#### THIRD READINGS SUMMARY SHEET

<u>CASE</u>: C814-2023-0057 (200 E. Riverside PUD) <u>DISTRICT</u>: 9

#### **ZONING CHANGE REVIEW SHEET**

<u>CASE</u>: C814-2023-0057 (200 E. Riverside PUD) <u>DISTRICT AREA</u>: 9

City of Austin
Council Meeting Backup: May 22, 2025

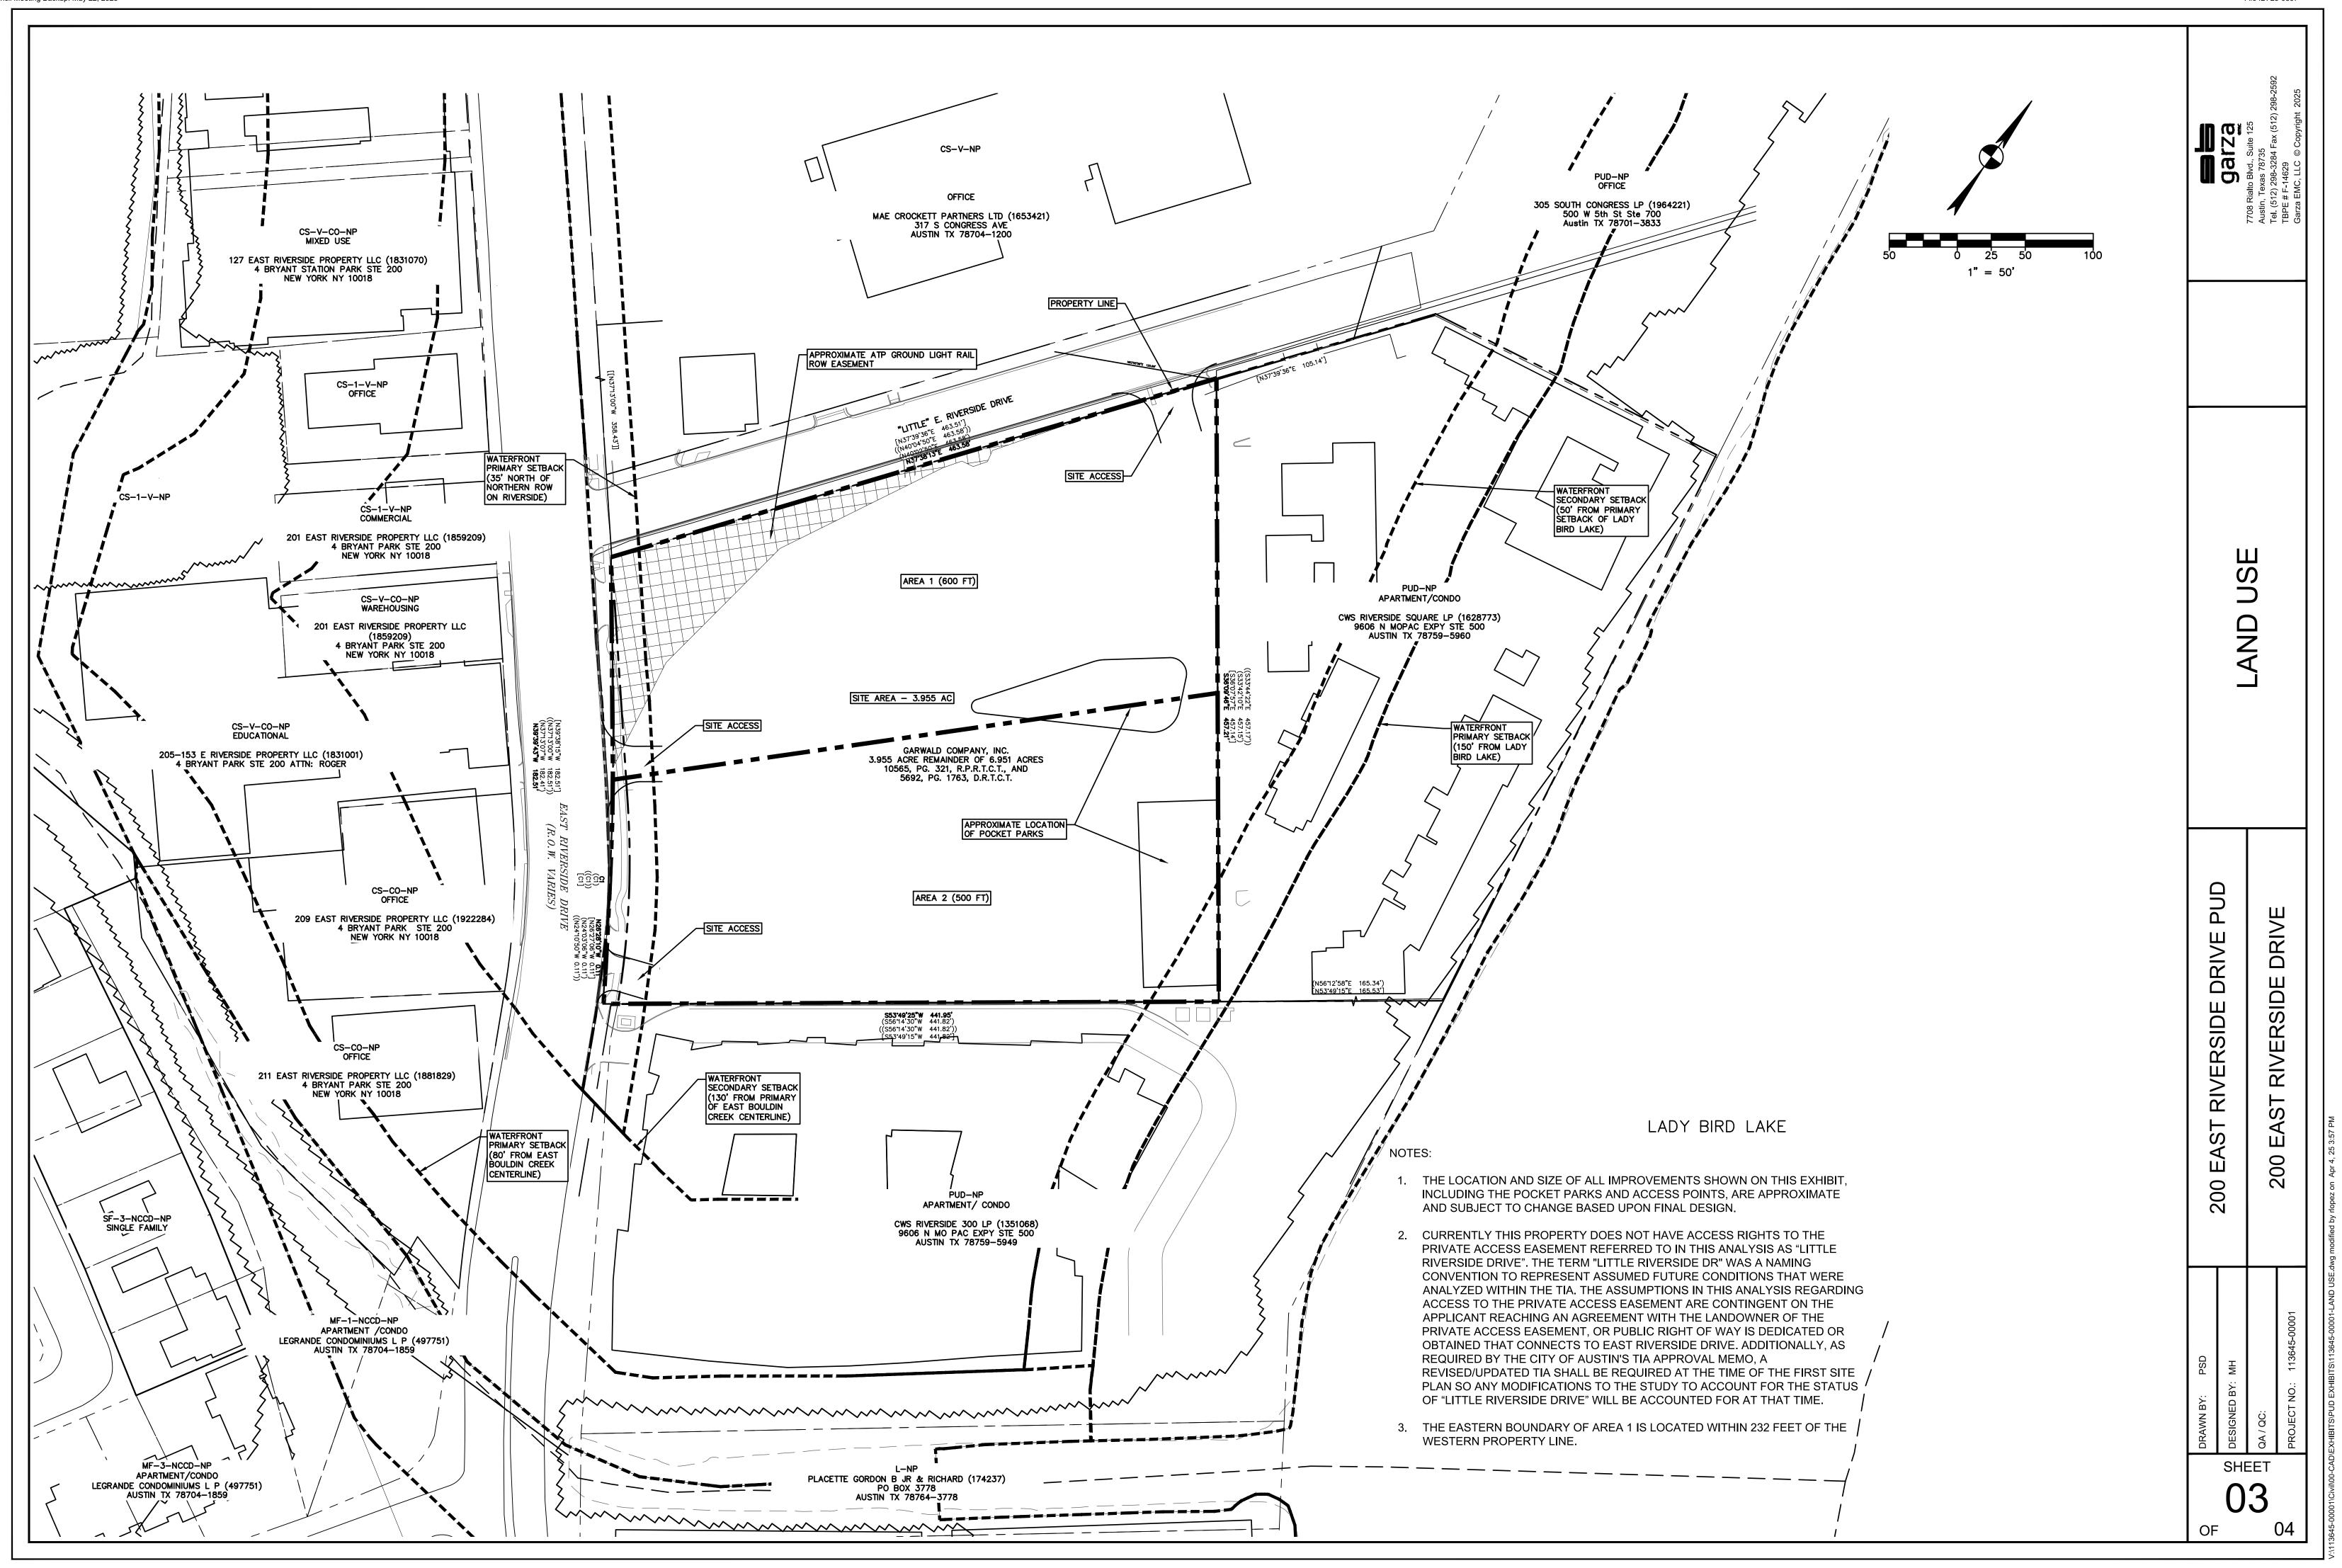
After meeting with the staff and City Council offices, on April 8, 2025, the applicant submitted a letter amending their application to modify the following conditions for the proposed PUD zoning (please see Applicant's Amendment Letter - Exhibit Q and Amended Exhibits - Exhibit R):

- 1. Increase the proposed maximum floor-to-area ratio ("FAR") to 25: 1.
- 2. Increase the maximum height allowed in Area 1 to 600 feet for buildings located within approximately 232 feet of the western property line as shown on the Land Use Plan.
